ADDENDUM # 2 SOLICITATION IFB # 2018-52

Oyster Factory Park Boat Ramp, Sidewalk and Drainage Improvements

RAMP FINISH DETAILS

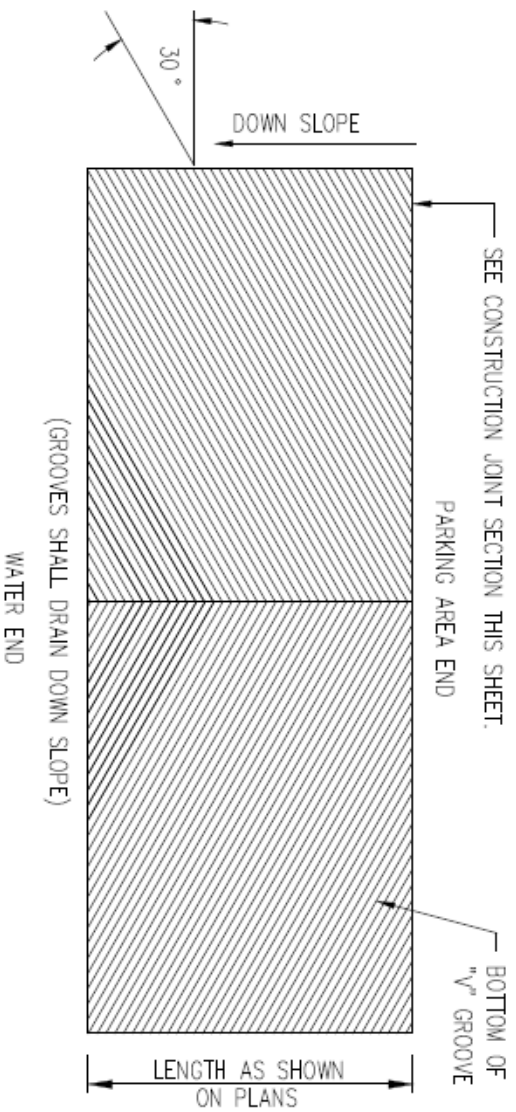
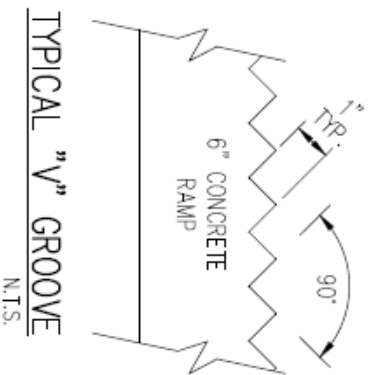
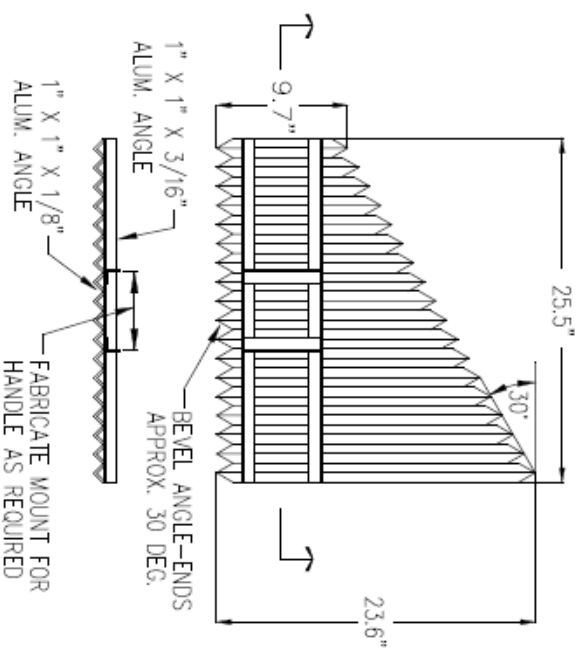
CLARIFICATION #2: Grooved Herringbone Finish Tool Detail Sheet C301 of the plans call out for 6" concrete pavement with grooved herringbone finish. This should be regular concrete color and we are attaching the detail for the groove tool fabrication in this addendum.

- NOTES:
1. ALL MATERIAL USED IN V-GROOVE TOOL TO BE TYPE 6061-T6 ALUMINUM.
 2. ALL WELDS ON V-GROOVE TOOL TO BE CONTINUOUS & GROUND SMOOTH.
 3. V-GROOVE FROM STA 0+80 UP TO 0+00. BROOM FINISH STA. 0+00 TO 0+10.
 4. NOTE: DO NOT PUSH SLAB INTO PLACE UNTIL ENGINEER APPROVES NON-SKID RAMP FINISH AND RAMP SUBGRADE GRADES.

Concrete ramp shall be bull floated to a smooth and uniform surface before grooving tool is used. The grooving tool must be worked until full grooves are worked into the concrete. The grooving tool shall be pushed or pulled across the surface of the concrete in a reasonably straight line in one continuous pass from the centerline at the specified angle. The tool shall penetrate the surface of the concrete 1/2" to 3/4". Grooves shall be at a 30 degree angle to the ramp edges. Contractor is required to use the V-groove tool as shown in the detail on the entire length of ramp. Caution shall be taken to perform the V-Groove finish at the proper time so that the grooves shall be relatively smooth uniform, without necessary tearing of the concrete surface. The finish surface shall be protected from rainfall and runoff until cured.
